Delegated officer report for planning application

Application no. 131876/FH/2021
Date registered valid: 11 October 2021
Proposal: Proposed first floor balcony and insertion of door to provide access
Address: 34 Lambton Road, Manchester, M21 0YJ
Ward(s): Chorlton Park Ward

Proposed first floor balcony and insertion of door to provide access

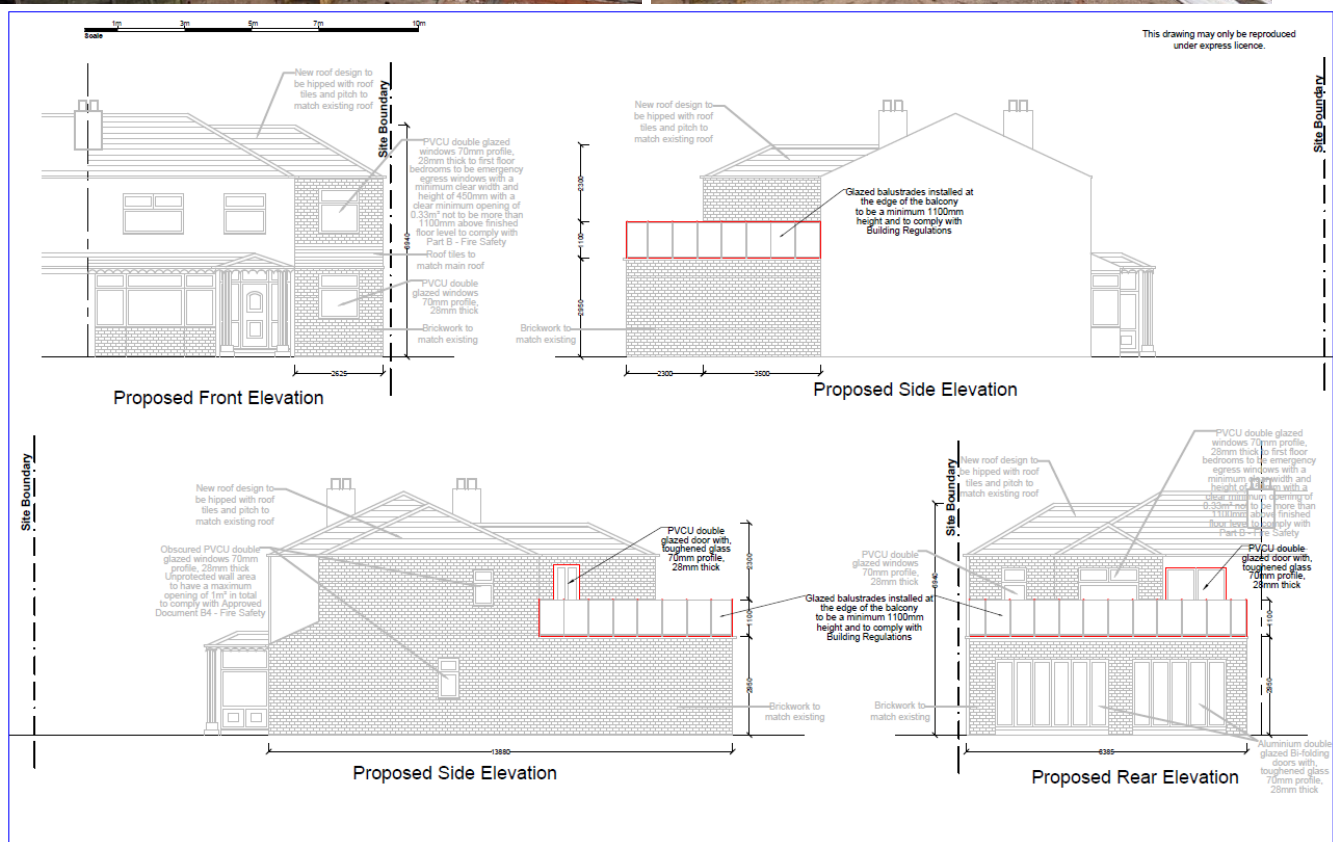
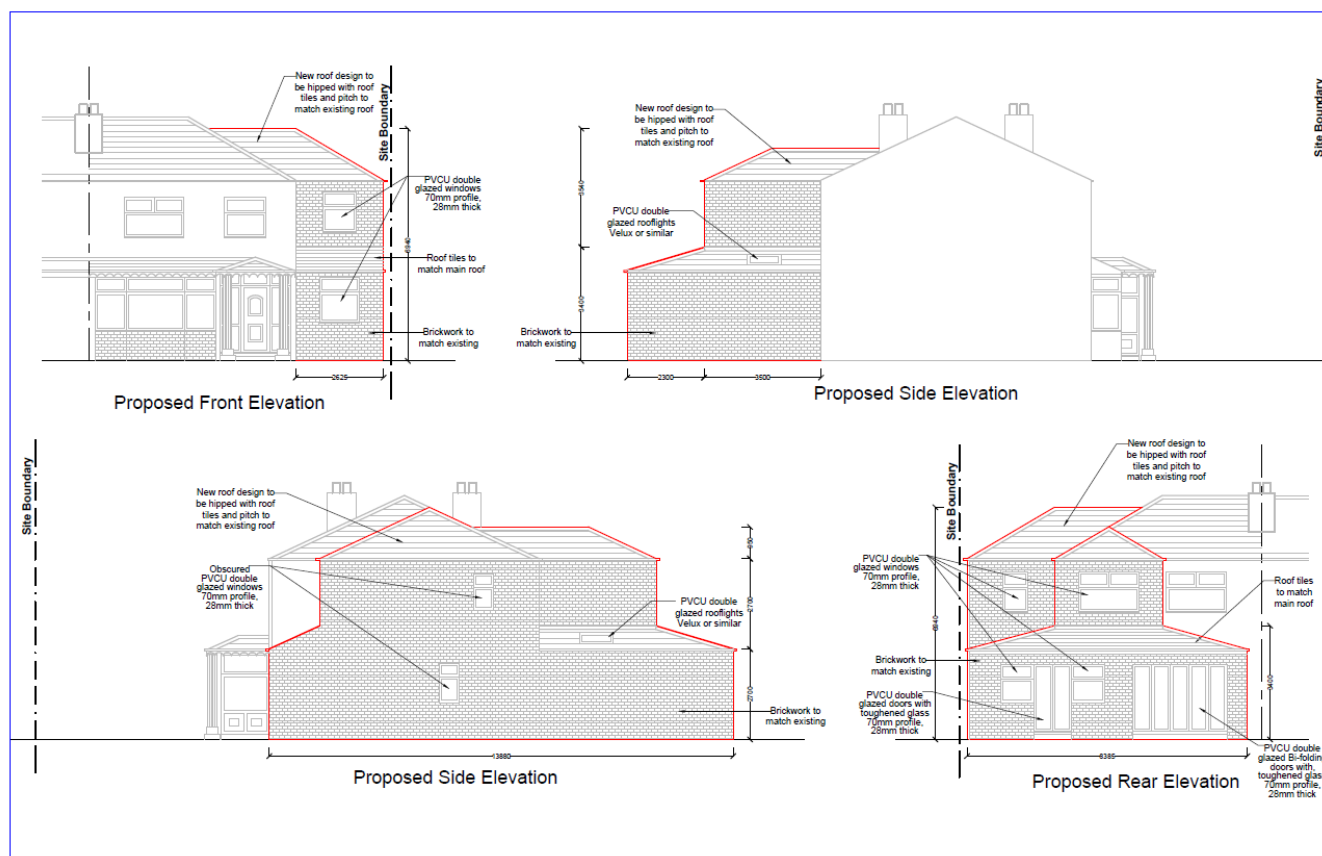
The balcony would project 5.8m from the rear building line for 8.385m width behind a 1.1m glazed balustrade. The balcony would be accessed through the insertion of a glazed door to the side elevation of the approved first floor rear extension facing towards the shared boundary with the neighbour to the north. The structure would not be visible within the street scene and would be appropriately detailed.

Impact upon residential amenity – An objection was received from a local resident which raised several concerns, including overlooking and loss of privacy. The balcony would face several habitable windows with the adjacent properties to the north and south. The space between the properties is c.0.4m to the shared boundary with the attached semi-detached property to the south and c.0.3m from the shared boundary with the property to the north, therefore anyone using the proposed balcony would have direct and unobstructed views (above the 1.1m glazed balustrade) over the neighbouring windows and gardens, causing an undue loss of privacy. Normally for applications for balconies the applicant would be asked to include a 1.8m privacy screen to the side(s) facing neighbouring properties to prevent this unacceptable degree of overlooking, however a screen attached to the extent of development proposed would have an overbearing impact that would result in loss of light to neighbouring properties to the north and south, hence the concerns regarding this proposal could not reasonably be mitigated.

The insertion of the glazed door into the side elevation of the first floor rear extension to provide access to the balcony would also provide direct overlooking to the property to the north, this

could not be obscurely glazed to overcome concerns as it would have to be opened to provide access to the balcony and it could not be reasonably conditioned to be closed except for access to a balcony that would similarly provide overlooking.

- 1) The proposed balcony, by reason of its height and siting, in close proximity to the boundary with the adjacent properties would give rise to undue overlooking and a loss of privacy to the detriment of the amenity that the adjoining occupants could reasonably expect to enjoy. As such the proposal is contrary to saved policy DC1 of the Unitary Development Plan for the City of Manchester and policies DM1 and SP1 of Manchester's Core Strategy Development Plan Document and the NPPF.
- 2) The proposed door to the side elevation facing north would give rise to undue overlooking and a loss of privacy to the detriment of the amenity that the adjoining
